# Part 5 Approval **ACCESS REPORT**

**Reference Number:** 21384

**Site Address:** 70-72 Gordon Ave, South Granville, NSW

Issue	Date	Details
F	27-09-2023	Issued for Part 5 Approval

The unit designated as adaptable – unit number TH08 (Voluntarily – not required under the BCA/NCC)

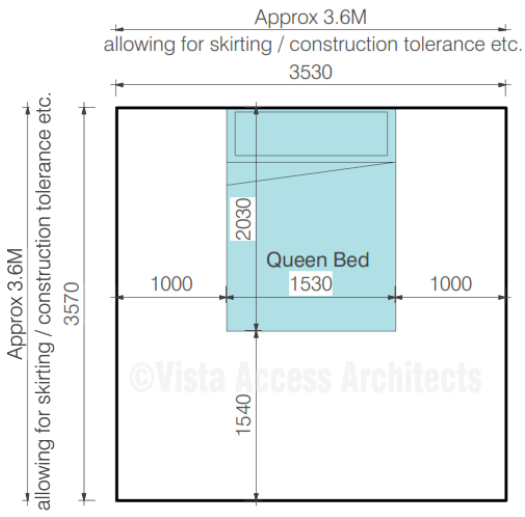
By incorporating the essential requirements listed Checklist below in the Specifications, the nominated Adaptable units can achieve full compliance with Adaptable House Class C

Since all the required features of 1 living area, 1 kitchen, 1 laundry, 1 bathroom, 1 bedroom are provided on the ground floor level, lift access is not required to the upper floor level. This checklist therefore only lists requirements to the adaptable unit on the ground floor level.
